SOUTH HILL BUSINESS & TECHNOLOGY CENTER PARKING EXPANSION

Mark-up Legend	
Building Review	
Engineering Review	
Fire Review	
Planning Review	
Public Works Review	
Traffic Review

E21-0913
 2nd ReviewMay

WALLED INFILTRATION PLANTER SECTION
NO SCALE

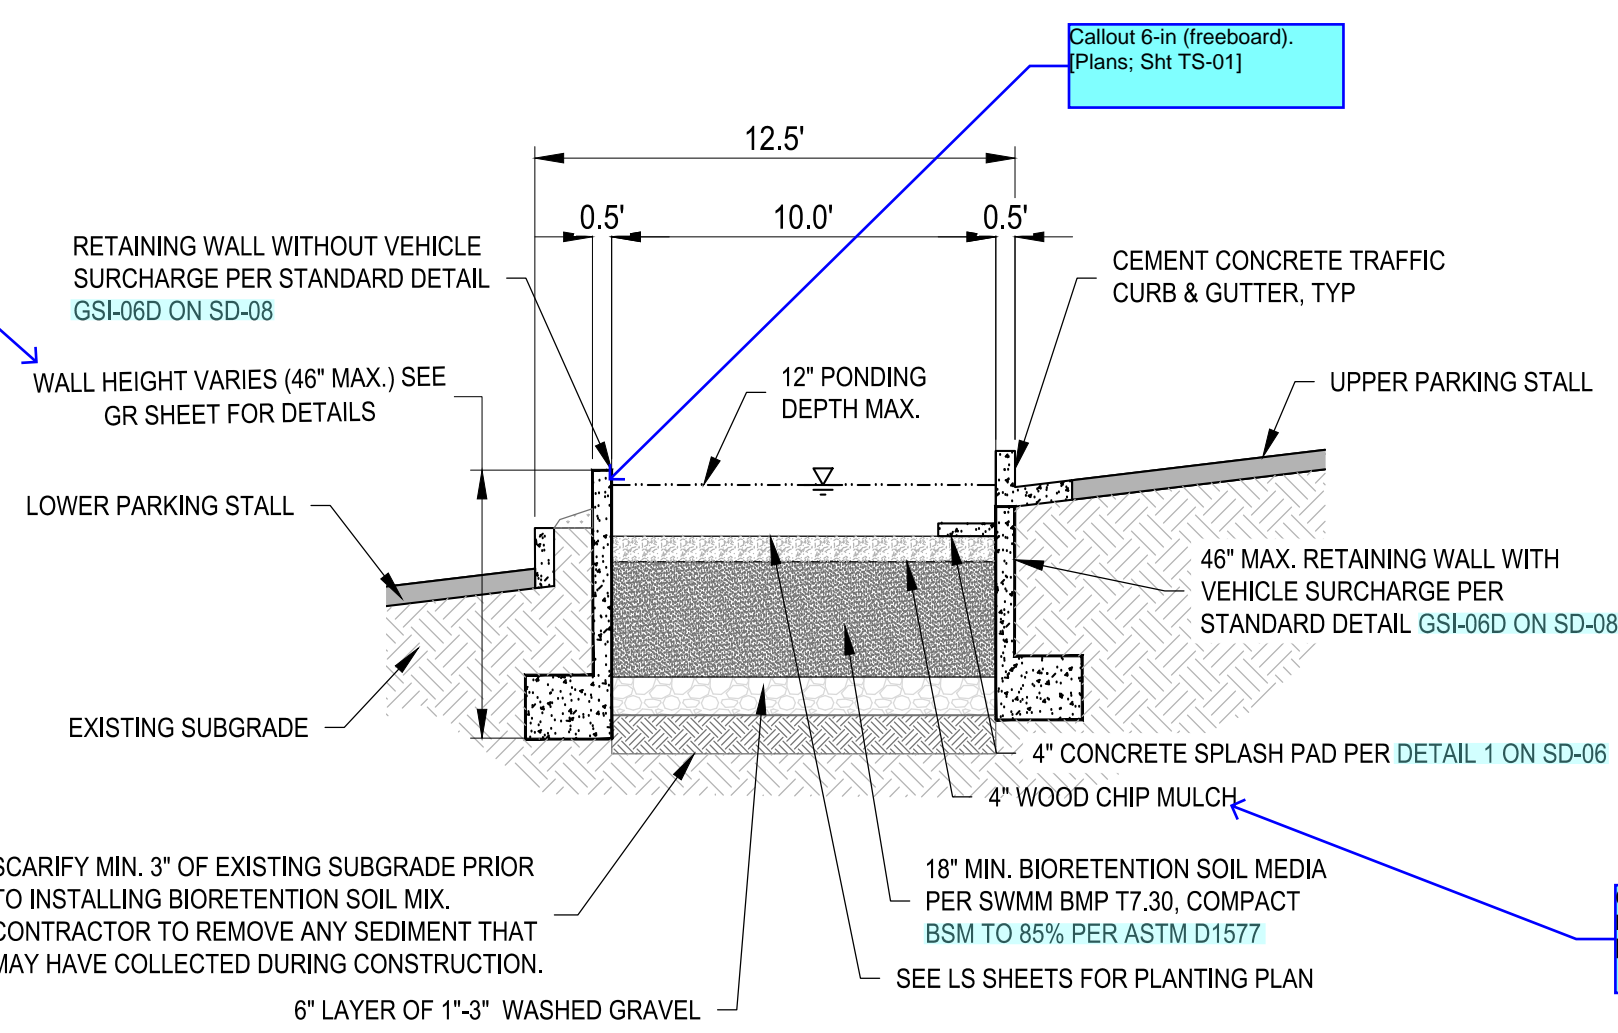
Verify 46-in max places bottom of footing exactly at bottom of biocell. (H=0.5*1.2+0.33*1+0.5 = 45.96inches) (Plans: SH TS-01)

LAYOUT: SD-00 PATH: U:\PSD\Projects\Cheris\7312-Beraroys\217-7312-004_SIB&TParkingExpansion\985\CAADD\DWG PLOTTED BY: petrus DATE: Friday, March 4, 2022 10:41:55 AM

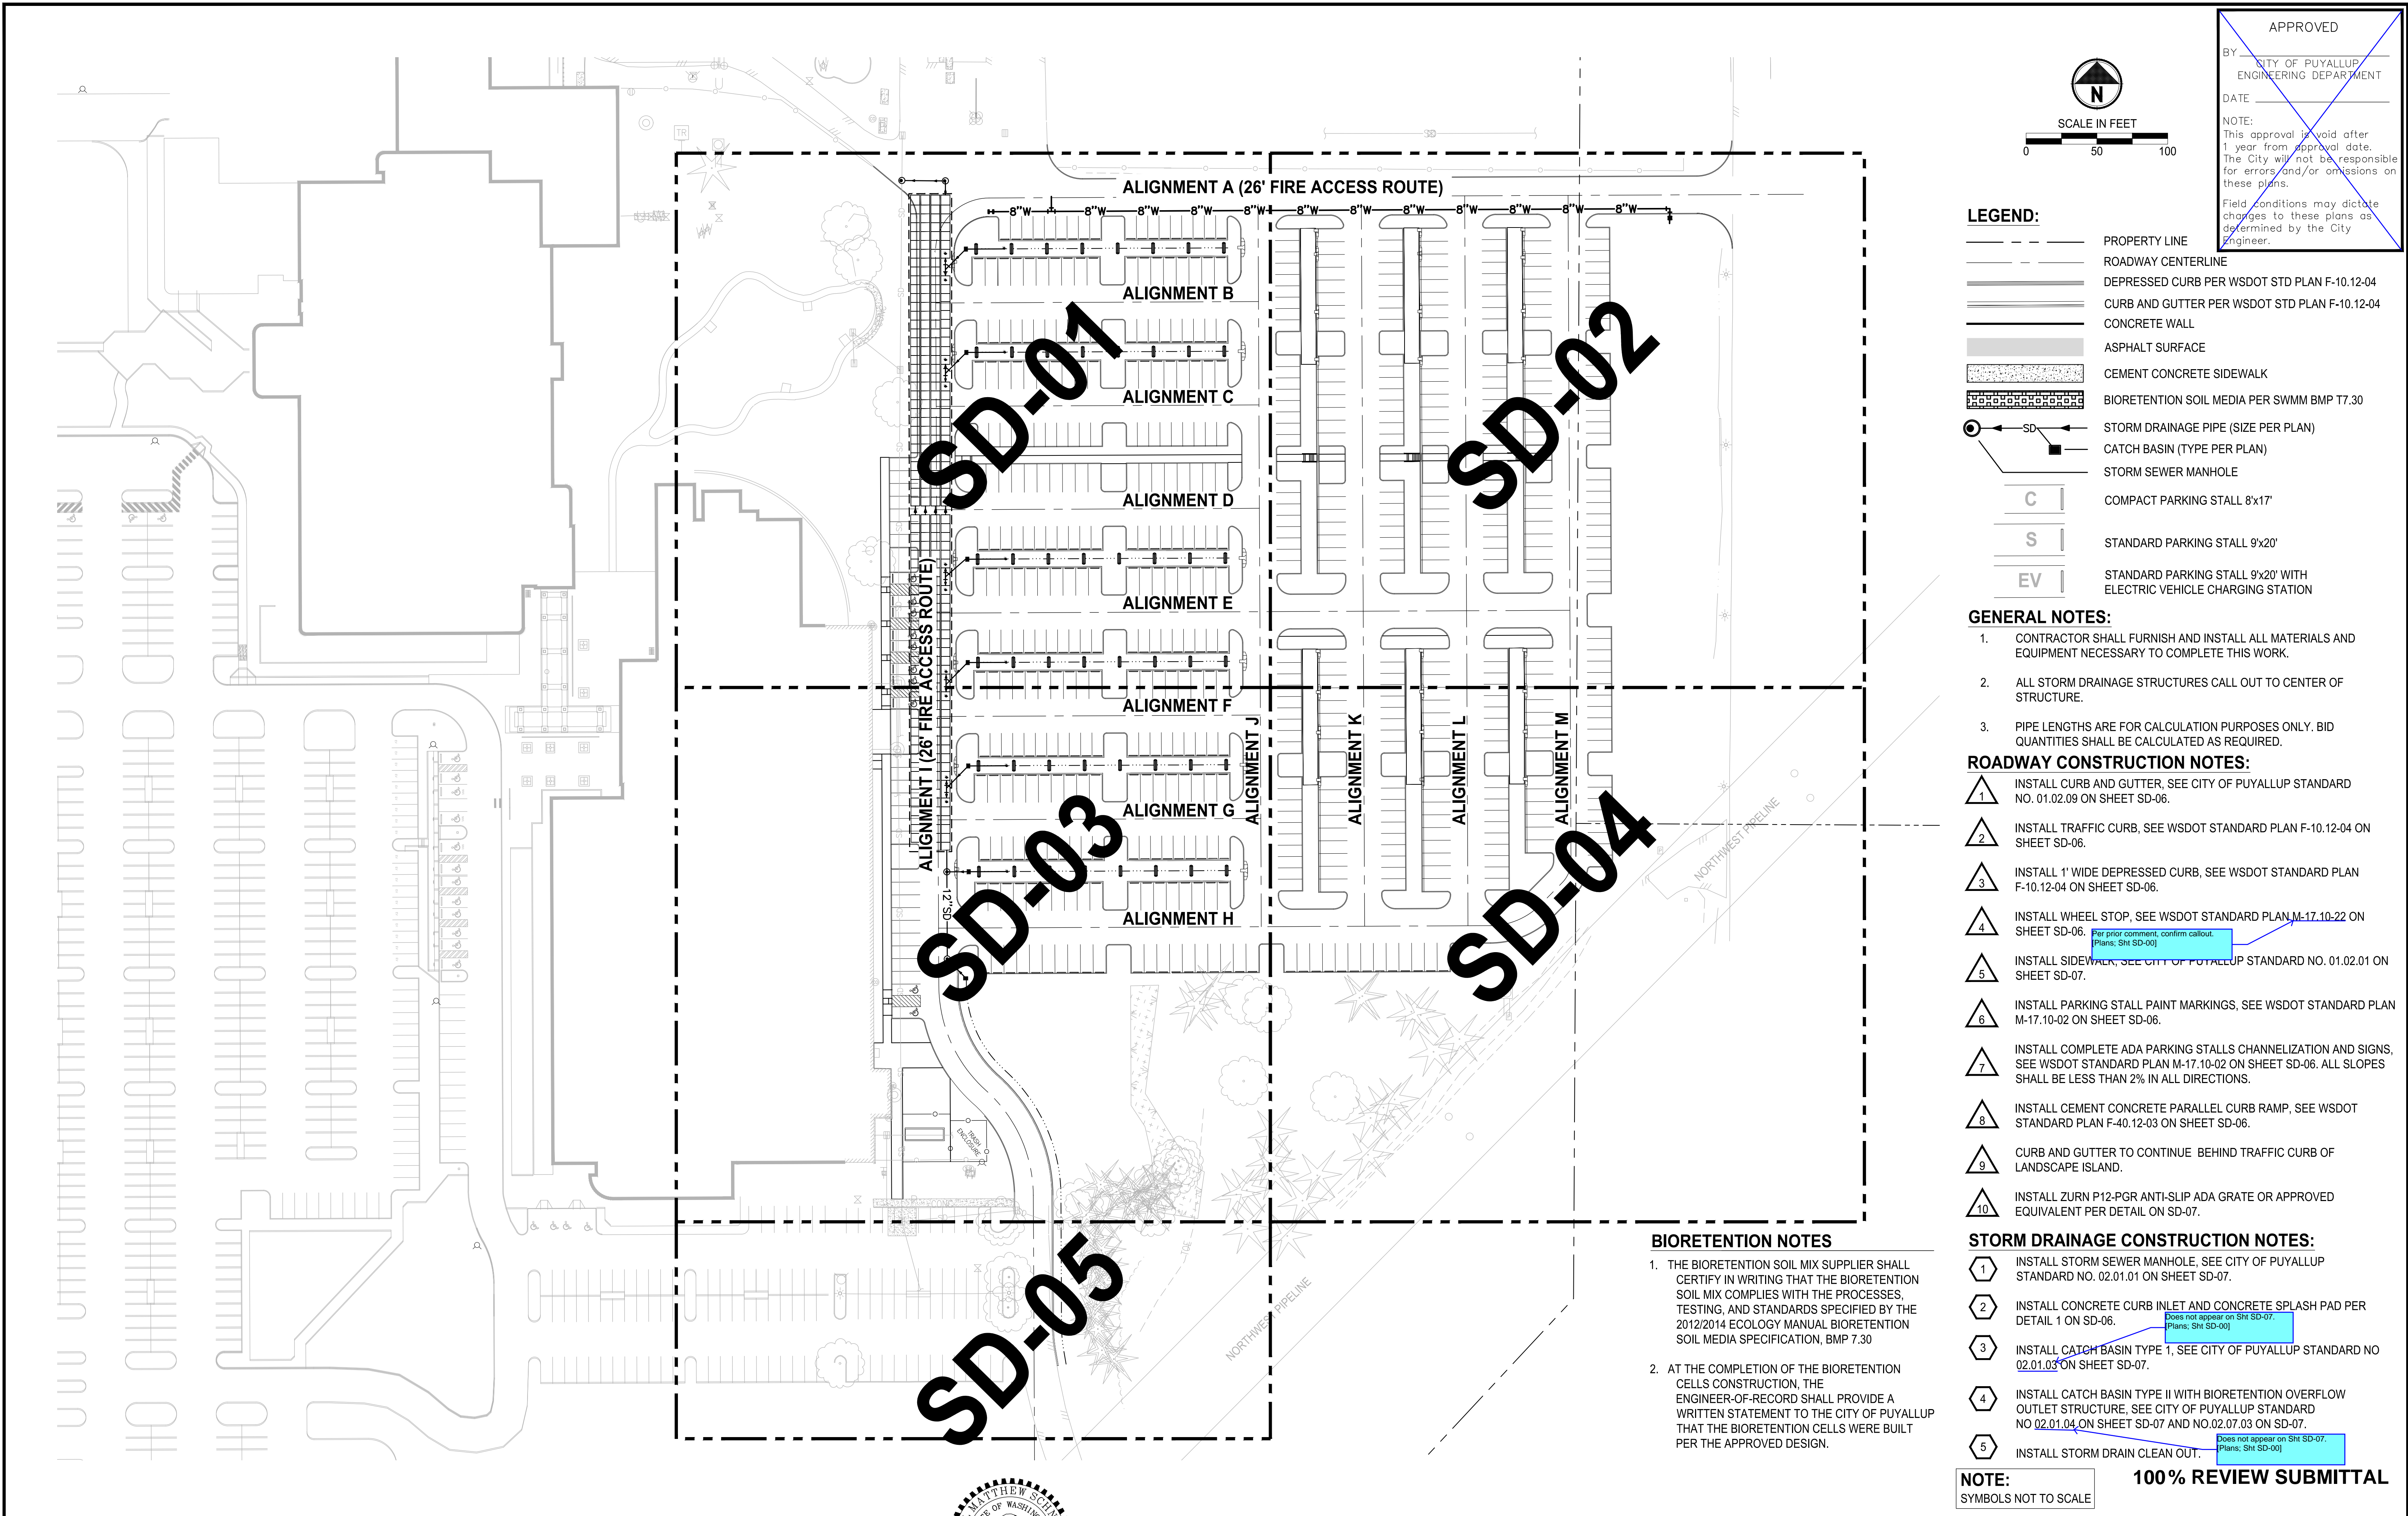
- INSTALL 1' WIDE DEPRESSED CURB, SEE WSDOT STANDARD PLAN F-10.12-04 ON SHEET SD-06.
 - INSTALL WHEEL STOP, SEE WSDOT STANDARD PLAN M-17.10-22 ON SHEET SD-06. *Per prior comment, confirm callout. (Plans: Sht SD-00)*

- STORM DRAINAGE CONSTRUCTION NOTES:**
- INSTALL STORM SEWER MANHOLE, SEE CITY OF PUYALLUP STANDARD NO. 02.01.01 ON SHEET SD-07.
 - INSTALL CONCRETE CURB INLET AND CONCRETE SPLASH PAD PER DETAIL 1 ON SD-06. *Does not appear on Sht SD-07. (Plans: Sht SD-00)*
 - INSTALL CATCH BASIN TYPE 1, SEE CITY OF PUYALLUP STANDARD NO 02.01.03 ON SHEET SD-07.
 - INSTALL CATCH BASIN TYPE II WITH BIORETENTION OVERFLOW OUTLET STRUCTURE, SEE CITY OF PUYALLUP STANDARD NO 02.01.04 ON SHEET SD-07 AND NO.02.07.03 ON SD-07.
 - INSTALL STORM DRAIN CLEAN OUT. *Does not appear on Sht SD-07. (Plans: Sht SD-00)*

DRAWING NO.
33 OF 58
GR-04

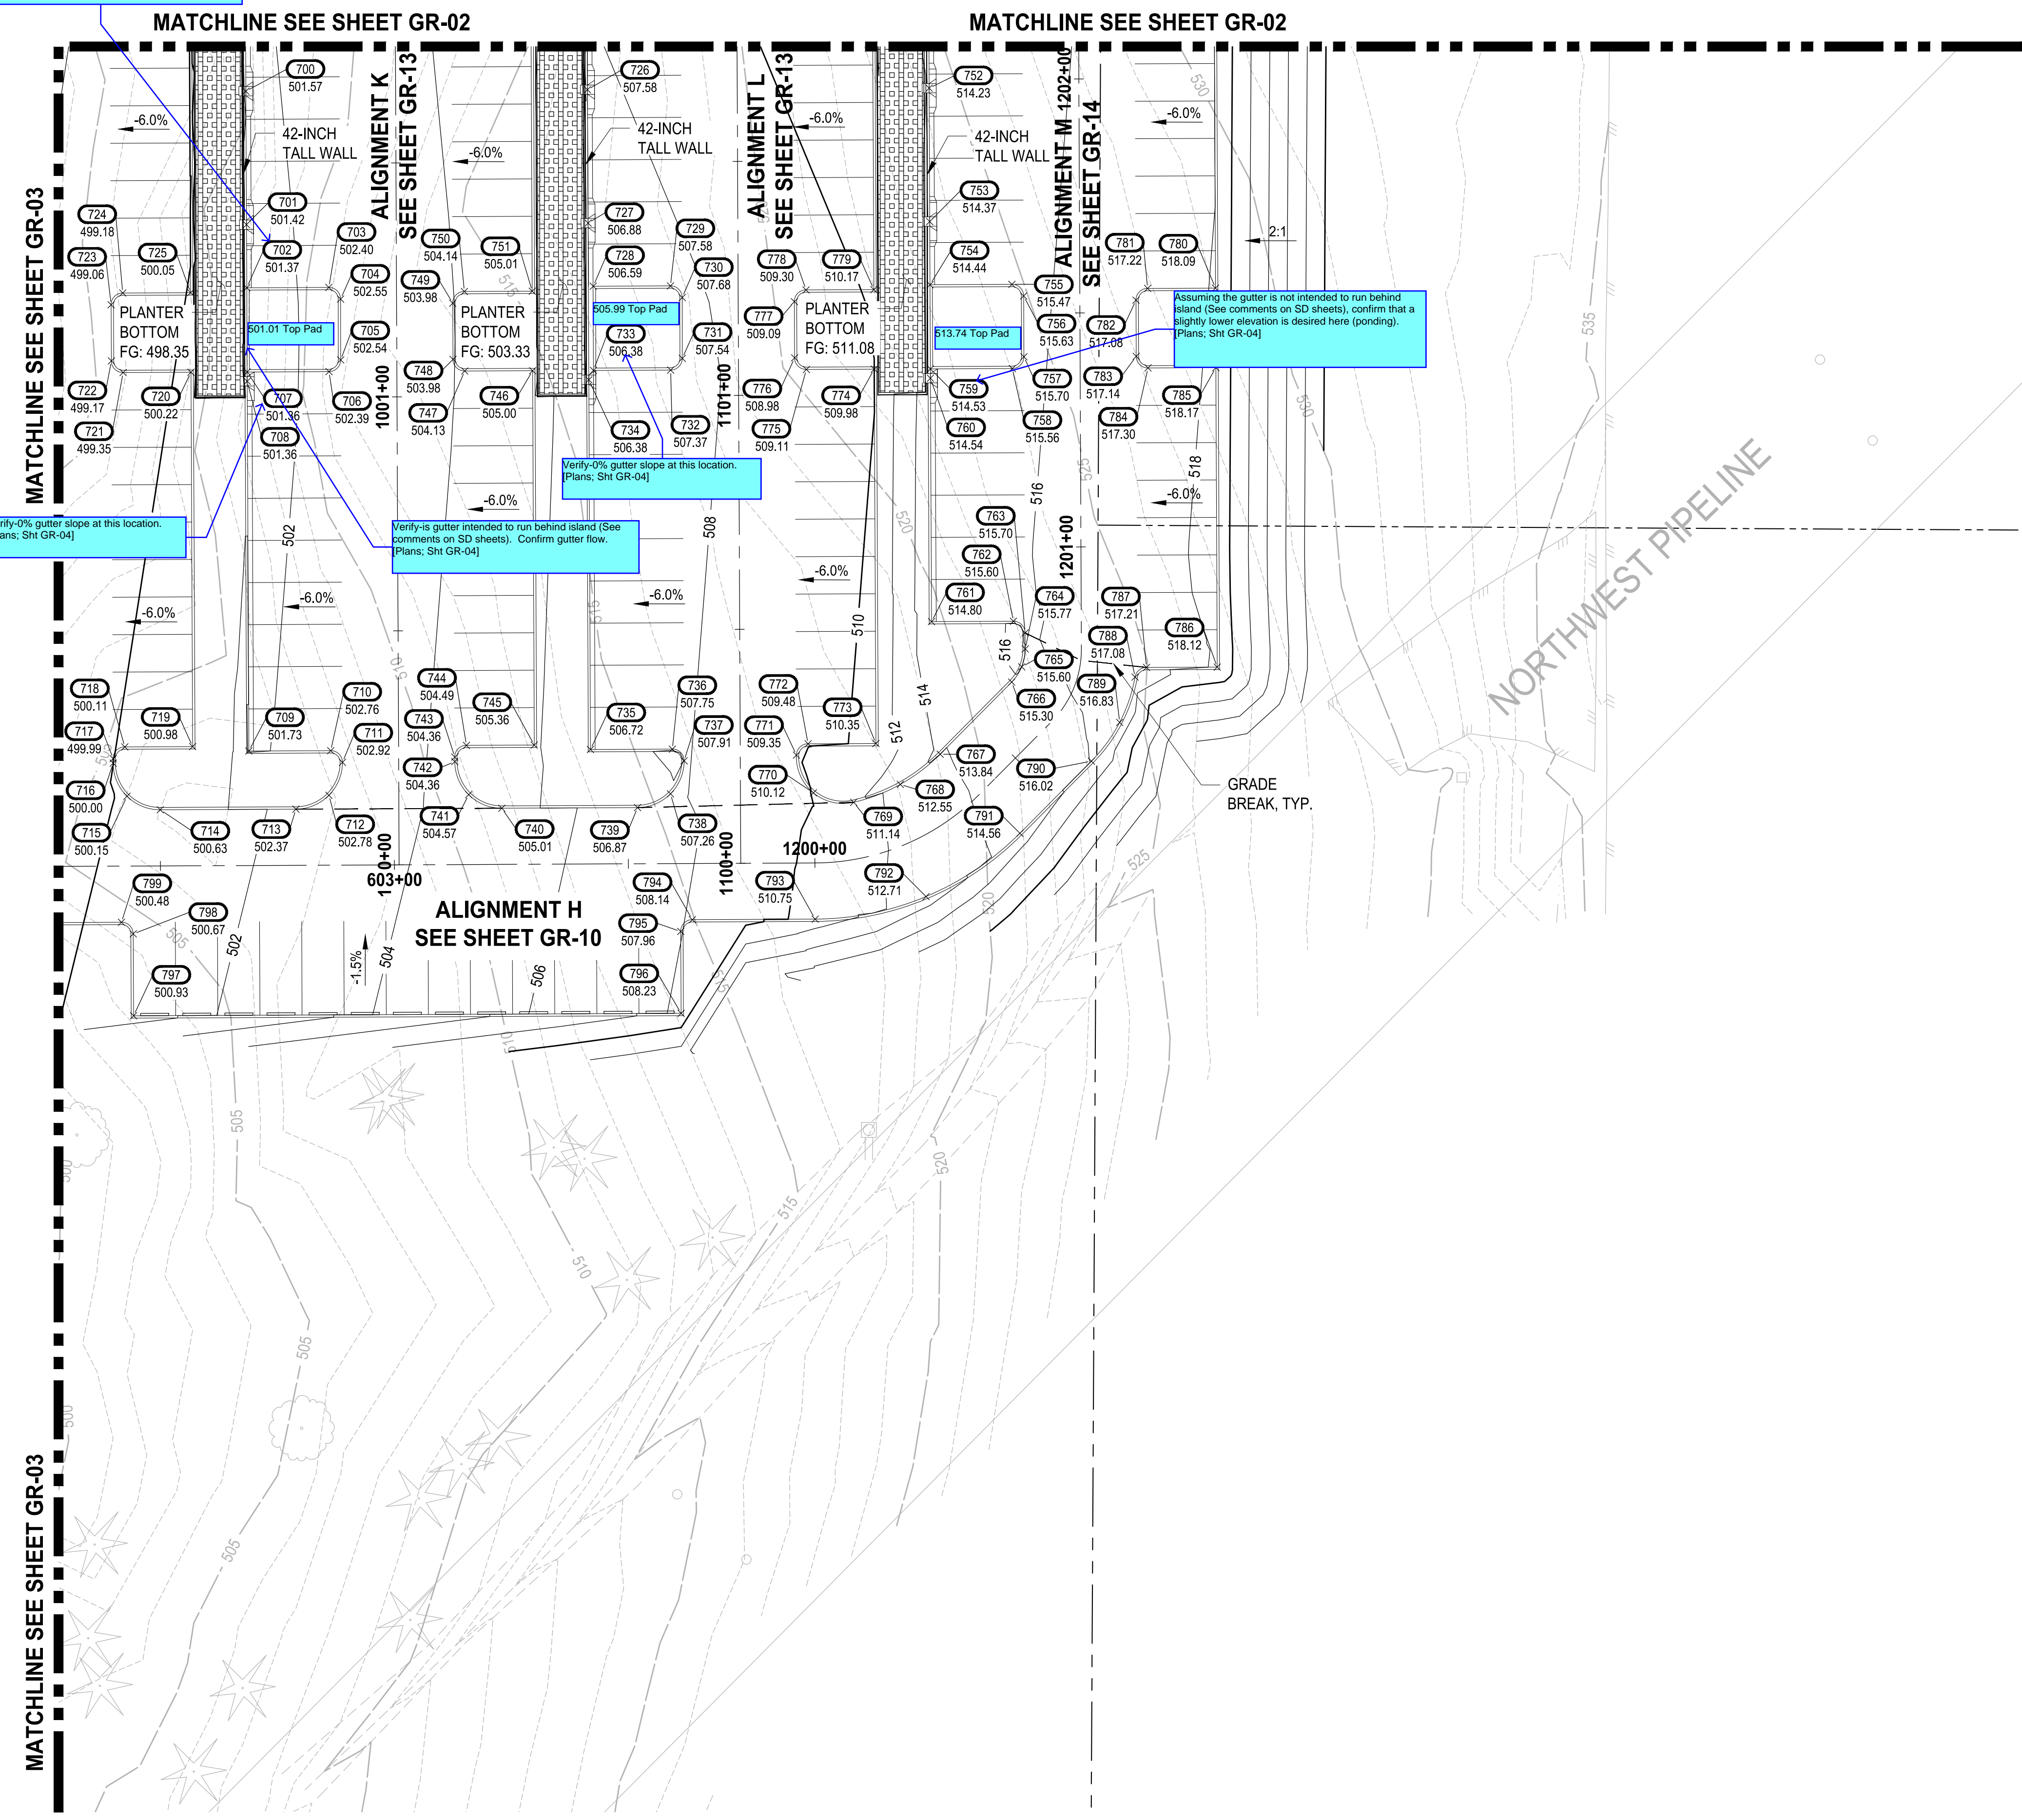
Verify if gutter does not run past, ponding at this location.
Plans: Sht GR-04
